# **Technical Service Information**

### SATURN NEW DESIGN SOLENOIDS

Figure 1

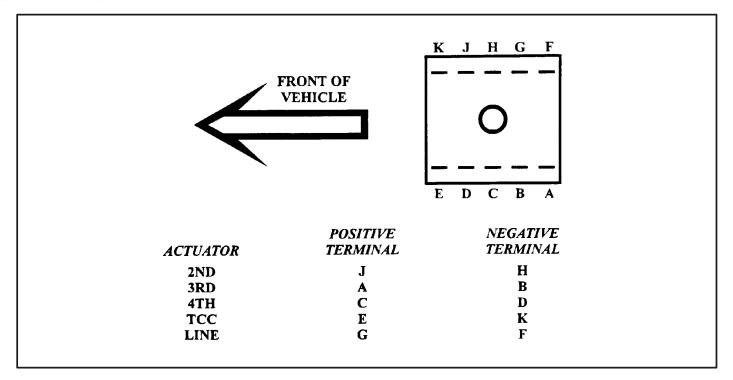
transmission connector located in the top pan, using a DVOM set to ohms. Refer to Figure 1 for a view of the actuator connector with each terminal identified. Each actuator has it's own positive and negative terminal as shown in Figure 1. As you are checking each actuator, refer

Figure 3
AUTOMATIC TRANSMISSION SERVICE GROUP

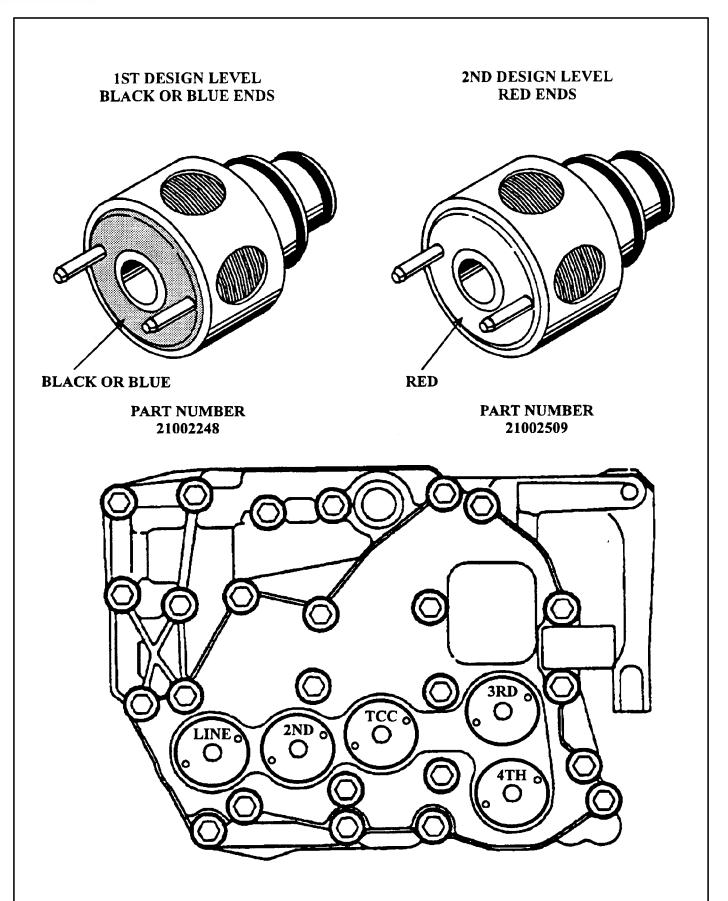
CAUSE: The cause may be, the wrong design level of actuators installed during rebuild. All 1991 and

1992 design level solenoids measure approximately 2.5 - 4.5 ohms resistance, while 1993 and Up solenoids measure approximately 4.0 - 6.0 ohms resistance. *These actuators*

(solenoids) will not interchange. (See Figure 3)

*Note:* The chart in Figure 2 provides the acceptable resistance values based on temperature and the year of the vehicle. All actuators should be within 1 ohm of each other. Also Saturn color coded the actuators as well, to assist in preventing the wrong design level actuators being installed. BLACK or BLUE ends on the Actuators are 1991 and 1992 design level for 91-92 vehicles only. The 1993-Up design level Actuators have a RED end and are for 93-Up

vehicles only, as shown in Figure 3.

CORRECTION: Install the correct design level solenoids. You can verify the solenoid resistance through the

Actuator (Solenoid) 1st Design (Black or Blue)	21002248
Actuator (Solenoid) 2nd Design (Red)	21002509
